Office Action Summary

09/173,134

DETAILED ACTION

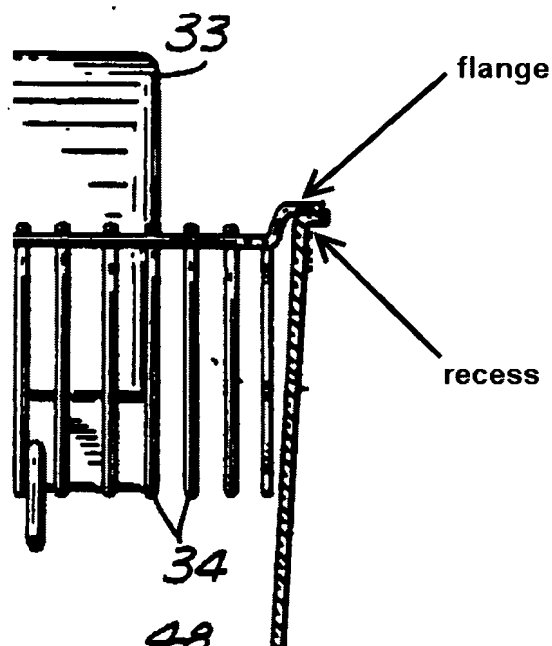
Sheaffer et al. teach cage assembly for housing a plurality of sizes of animals, the cage assembly comprising: a feeder assembly 32,33 having a flange 35 (see illustration below); and a cage bottom 22 for housing an animal, the cage bottom having a plurality of integral side walls having recesses therein (see illustration below) being constructed and arranged to receive the flange 35 of the feeder assembly; the cage bottom and feeder assembly working together to provide food and water to animals of different sizes.

As explained in the above rejection (emphasis on the illustration provided above), Sheaffer et al. do teach recesses in the side walls. The recesses do support the feeder assembly. The recesses are on the outside of the side walls creating the flange to support the feeder assembly.
